## City of Phoenix PLANNING AND DEVELOPMENT DEPARTMENT

**Staff Report: Z-SP-2-24-3**  
January 24, 2025

**Proposal:** Special Permit to allow sales, parts and service dealership for new and used UTV's, ATV's, motorcycles, personal watercrafts, etc., and all underlying C-2 uses

SHEET NO. **L1** OF 1

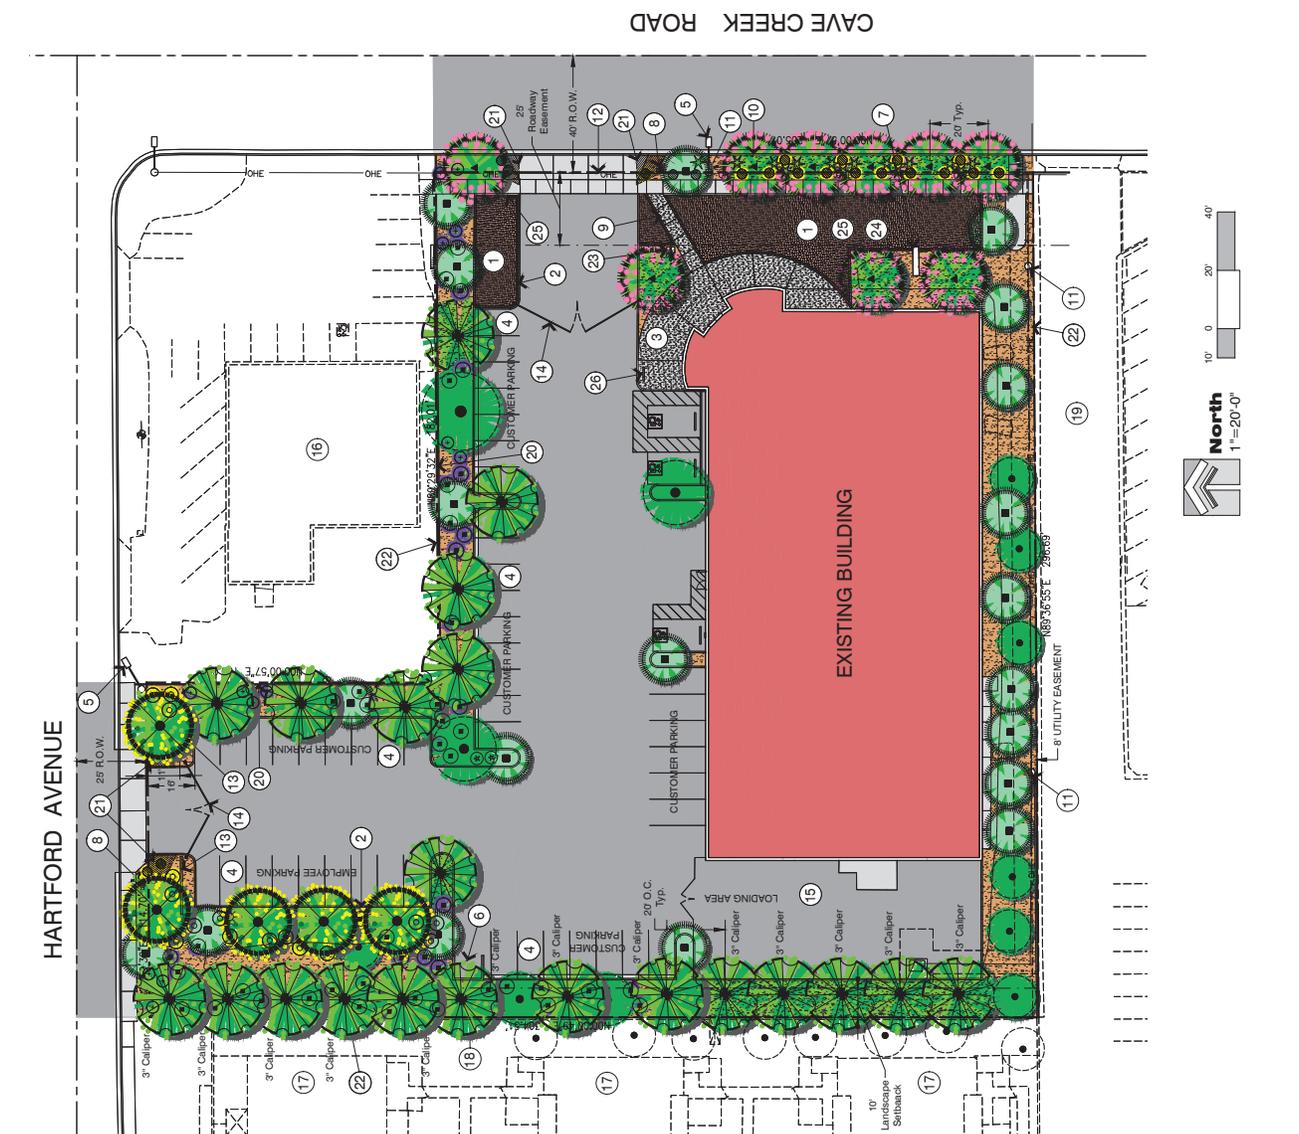
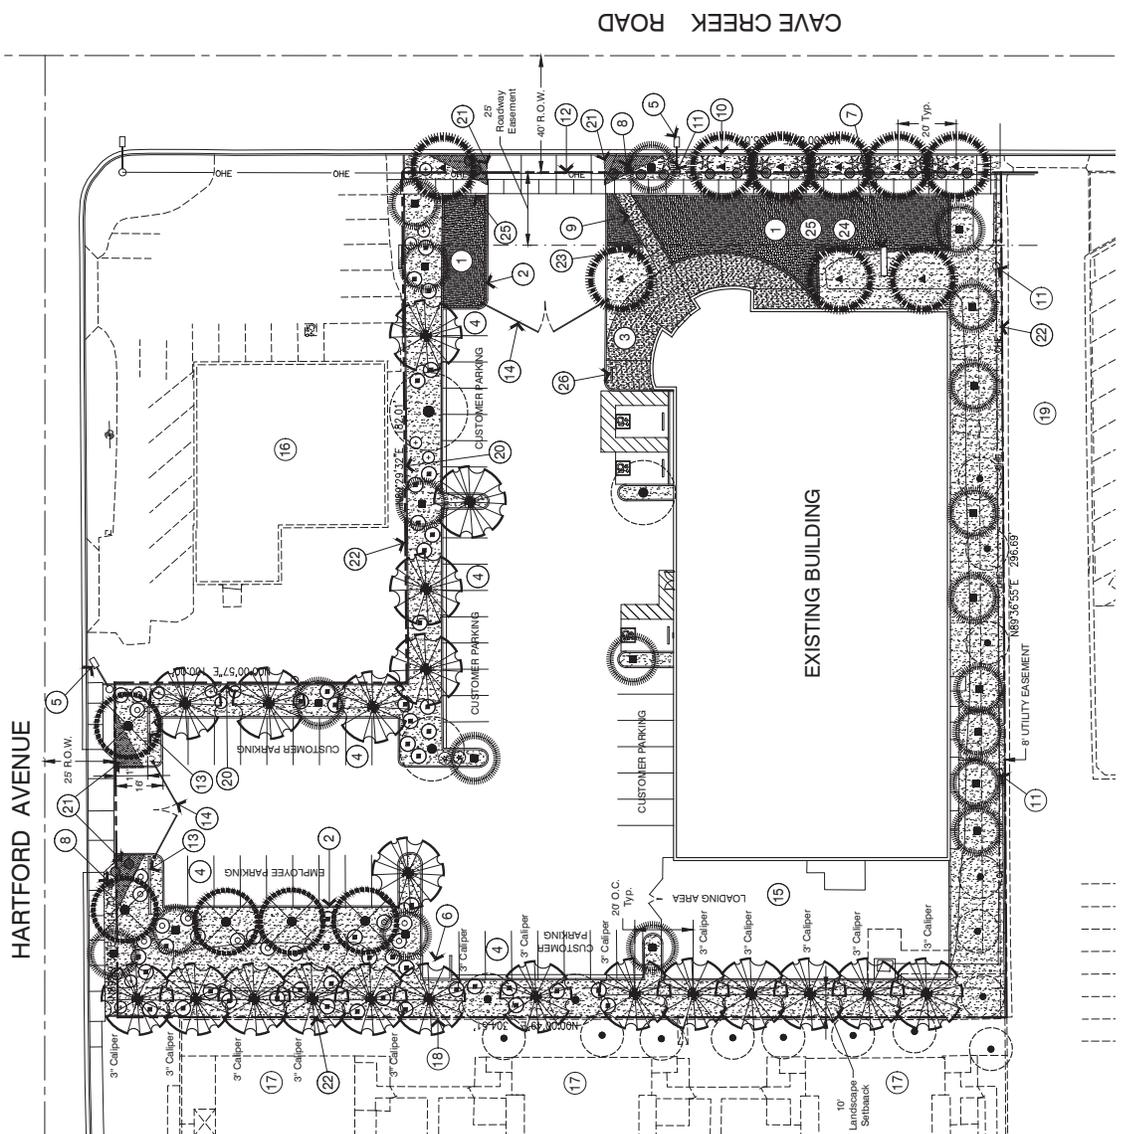
In order to ensure landscape areas are replenished with landscaping and to enhance shading, staff recommends that the perimeter landscape areas, retention basin, and surface parking lot areas be replenished with minimum two-inch caliper shade trees and shrubs. This is addressed in Stipulation Nos. 3 through 5.

3. The required perimeter landscape areas, and the perimeter landscape areas as depicted on the conceptual landscape plan date stamped January 9, 2025, shall be replenished with minimum 2-inch caliper, large canopy, shade trees, planted 20 feet on center or in equivalent groupings, and a minimum of five 5-gallon shrubs per tree, as approved by the Planning and Development Department.

Site Plan date stamped January 10, 2025

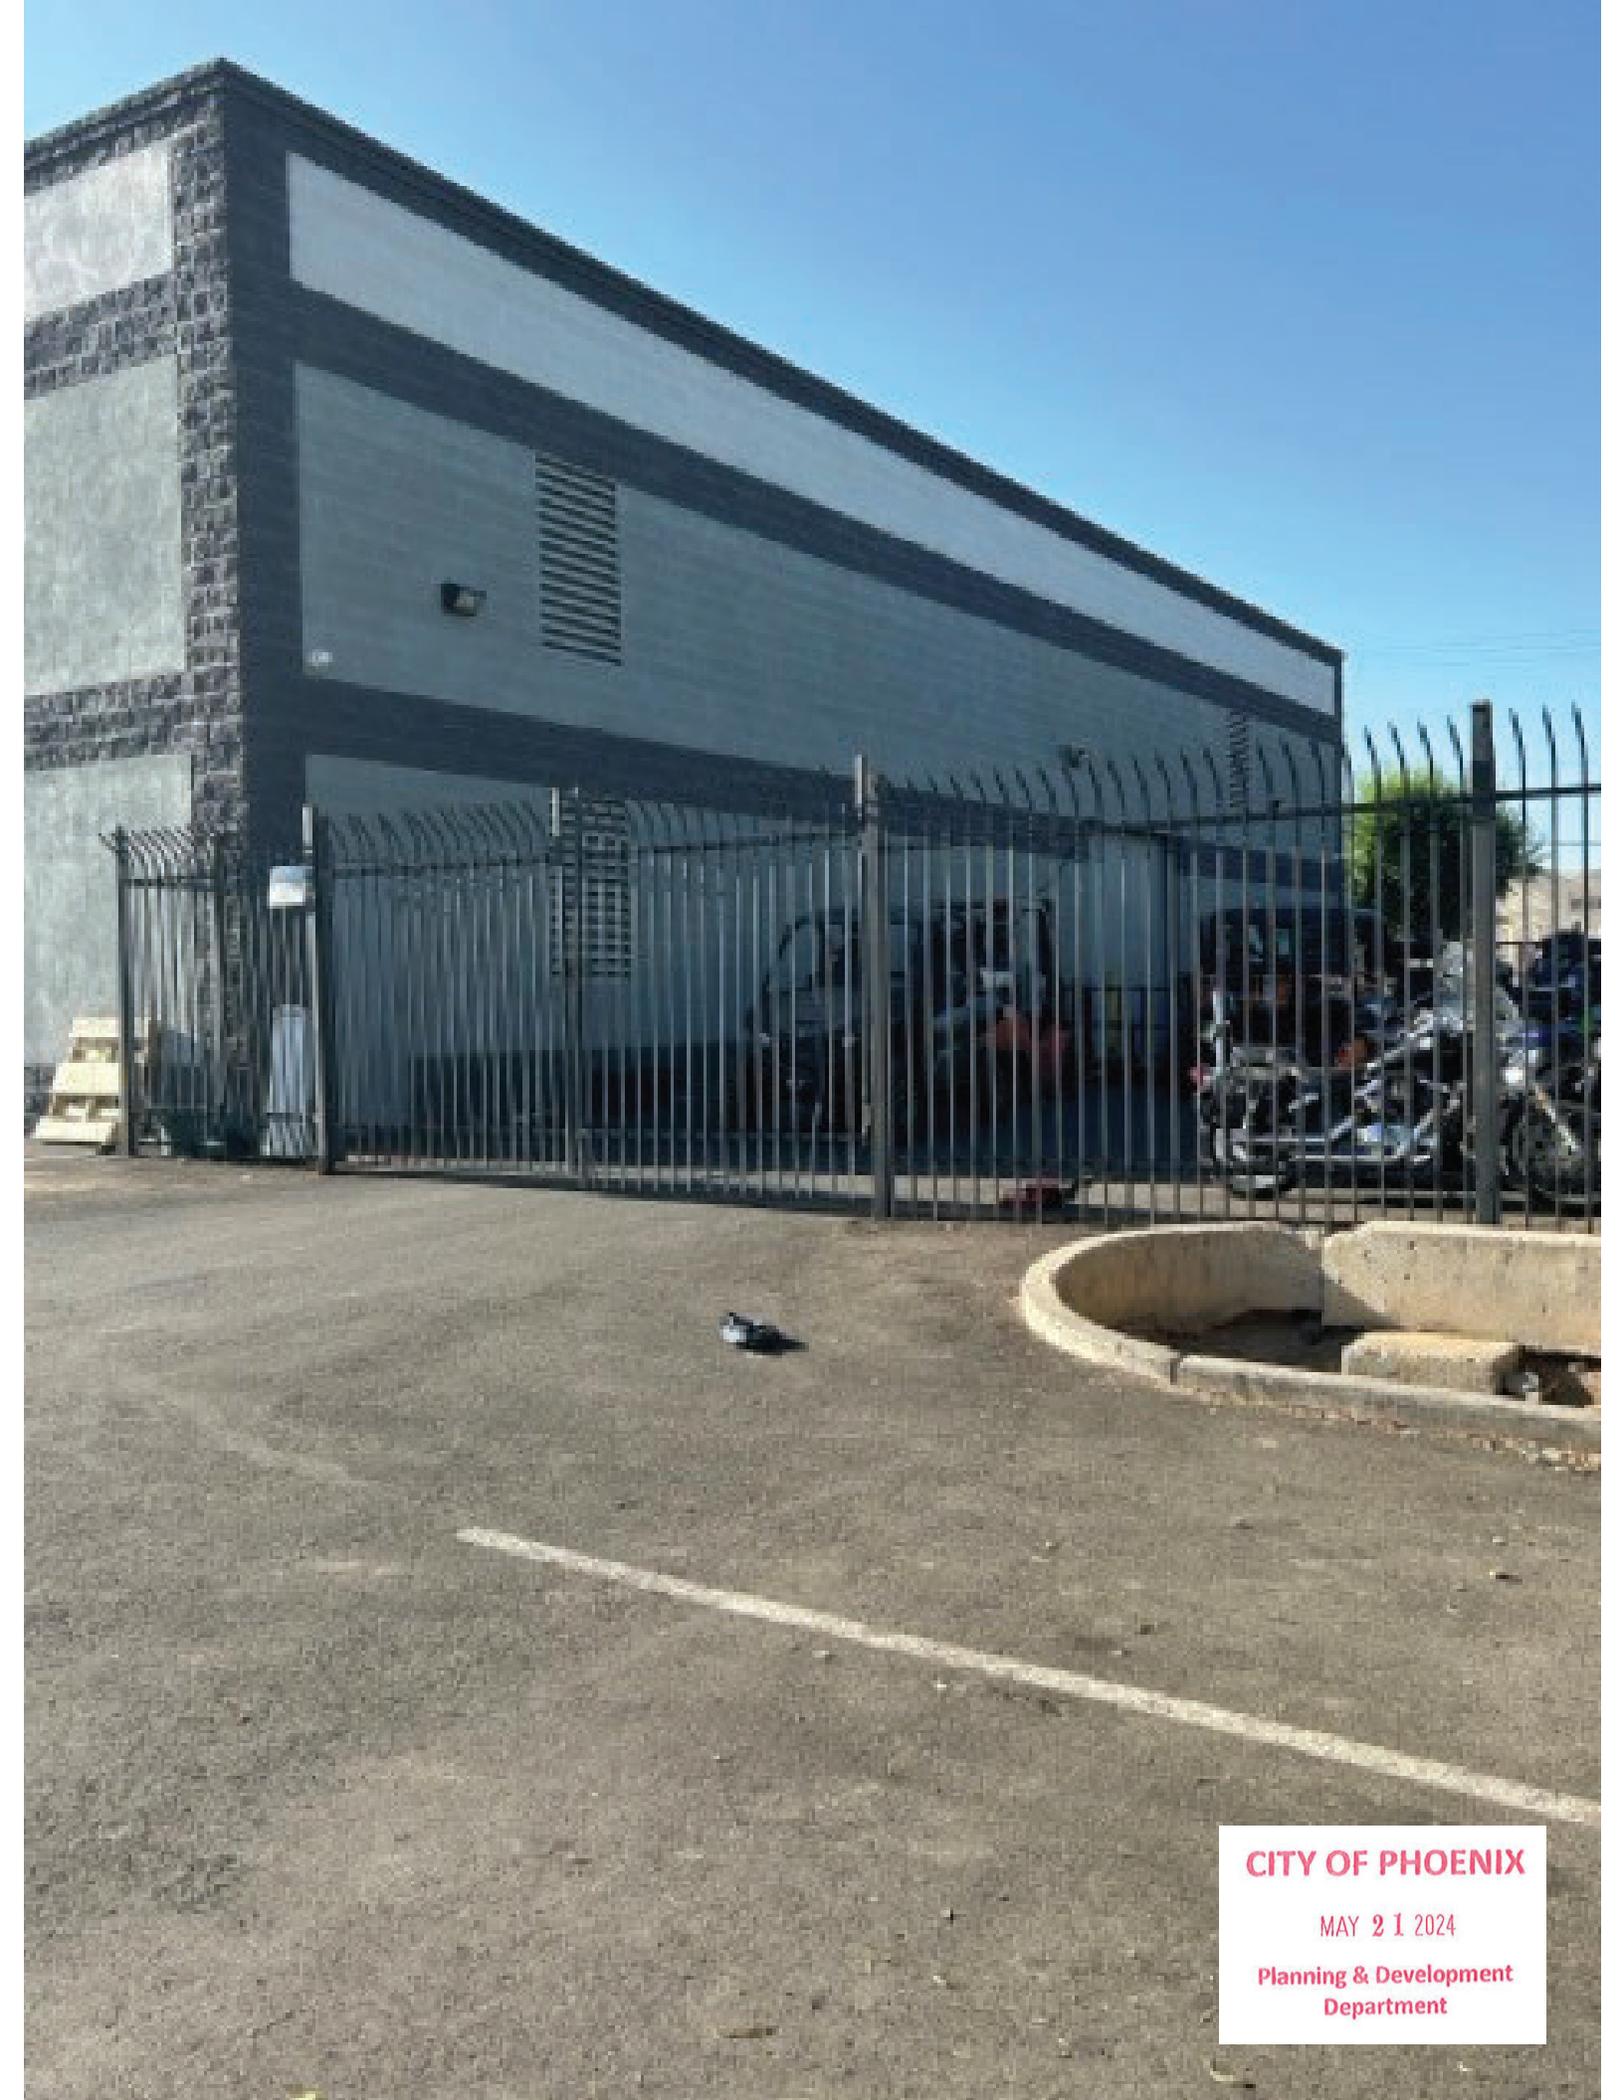
Due to the 25-foot right-of-way easement along the east property line, adjacent to Cave Creek Road, the existing building does not meet the average 25-foot building setback and landscape setback required by the C-2 zoning district. Additionally, the proposal has pavers and outdoor display of vehicles for the full width of where an average 25-foot landscape setback would be required along some portions of the street frontage. Lastly, the landscape setback provided along Hartford Avenue does not meet the average 25-foot landscape setback required by the C-2 zoning district. Since the proposal does not meet building and landscape setback requirements, and variances would be required, staff does not recommend general conformance to the site plan.

In order to limit the outdoor display area of vehicles built to carry passengers or cargo, staff recommends that the maximum area for outdoor display of vehicles be 3,100 square feet and be clearly identified on the site plan. This is addressed in Stipulation No. 1.

In order to limit and screen parking or staging areas for vehicles built to carry passengers or cargo needing repair, staff recommends that the maximum parking or staging area for vehicles built to carry passengers or cargo needing repair be 4,000 square feet and be clearly identified on the site plan, located within a screened area behind the existing building and setback from the street. This is addressed in Stipulation No. 2.

1. The maximum area for outdoor display of vehicles built to carry passengers or cargo shall be 3,100 square feet and shall be clearly identified on the site plan, as approved by the Planning and Development Department.

2. The maximum parking or staging area for vehicles built to carry passengers or cargo needing repair shall be 4,000 square feet and shall be clearly identified on the site plan, located within a screened area setback a minimum of 185 feet from the north property line and a minimum of 200 feet from the east property line, as approved by the Planning and Development Department.

4. The existing retention basin, as depicted on the site plan date stamped January 10, 2025, shall be replenished with minimum 2-inch caliper, large canopy, shade trees, planted 20 feet on center or in equivalent groupings, and a mixture
